# Village of Arlington Heights Building & Life Safety Department

**To:** Sam Hubbard, Development Planner, Planning and Community Development  
**From:** Deb Pierce, Plan Reviewer, Building & Life Safety Department  
**Subject:** 519 W Algonquin Rd. – Land Use Variation – European Crystal Hotel  
**PC#:** 18-013 – Round 1  
**Date:** May 14, 2018

**PLAN COMMISSION PC #18-013**  
**European Crystal Hotel**  
**519 W. Algonquin Rd.**  
**LUV for a Hotel**  
**Round 1**

Project: European Crystal Hotel  
519 W. Algonquin Road  
Arlington Heights, IL 60005  
Land Use Variation for a Hotel  
P.C. #18-012  
Round 1

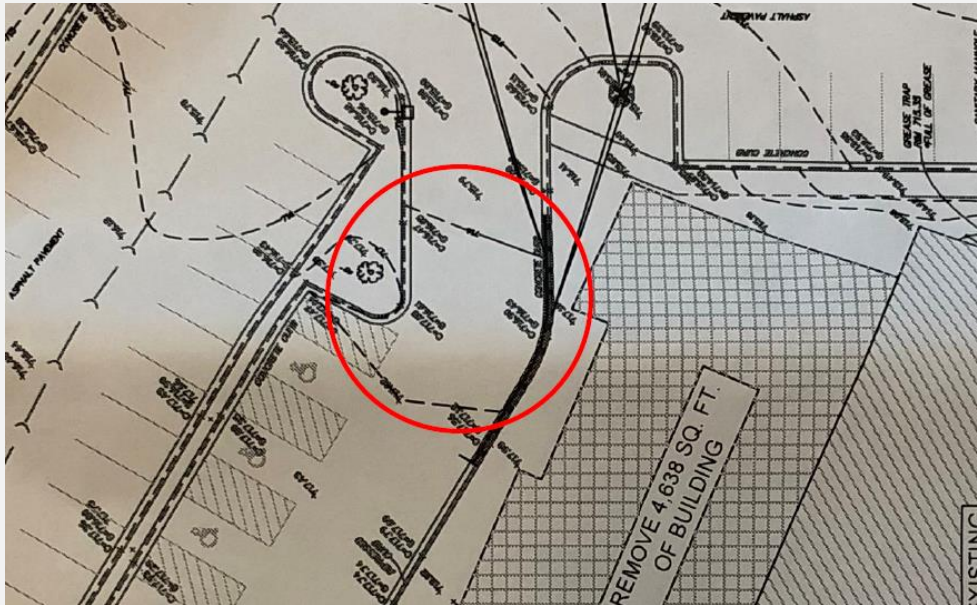
18. Please provide a dimension for the drive aisle in the following location:

Sheet 1 Proposed First Floor Plan:

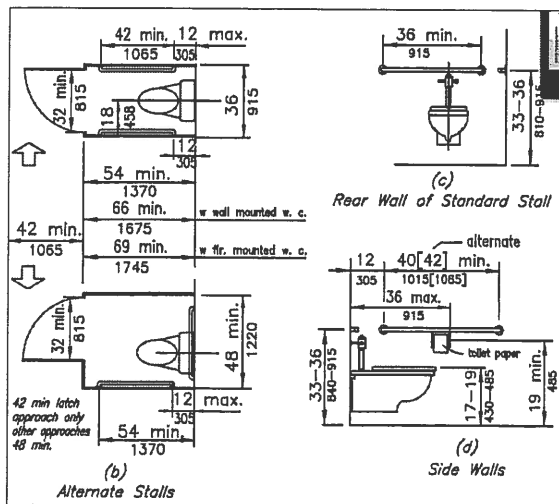
1. Women's Restroom: In restrooms with six or more toilet stalls in addition to the standard stall configuration for wheelchair accessibility complying with subsection (n)(5)(A) (ii), IAC Section 400.310(n)(5) requires the addition of a 36-inch wide toilet stall where the doors open out and is equipped with parallel grabs on each side of the stall per IAC 400.Illustration B. Figure 30(d) and q. Pictured below.

Fig. 54  
Tableware Areas

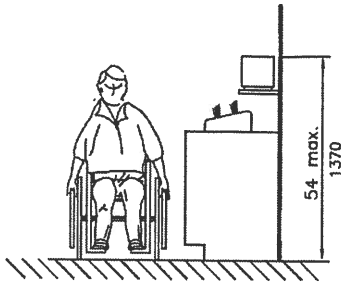
3. Coffee Vending Room: Please see IAC Section 400.320(l)(6 and 8) and 400.Illustration B., Figure 54.
